# Hopkinton Landfill Solar Project

## Addendum #10: October 15, 2020

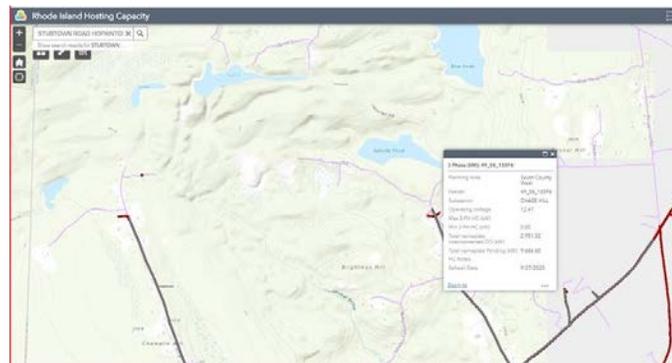
**Question:** Based on the utility Hosting Capacity map, National Grid does not appear to have capacity for the proposed array at this location. Does this site already have an interconnection request in queue? Please see the image below for clarification of the apparent lack of capacity. The substation feeding the projection location appears to be approximately 7 feeder miles from the site. Assuming the substation transformer can accept the PV, the cost to the project for an express feeder may be cost prohibitive. Can Hopkinton suggest and provide an assumed cost for interconnection to allow for uniform pricing assumptions? In our experience, the cost for an express feeder of this length can be in excess of \$3,000,000.

**Answer:** Please see response to a similar question posted on the Town website as Addendum 8.
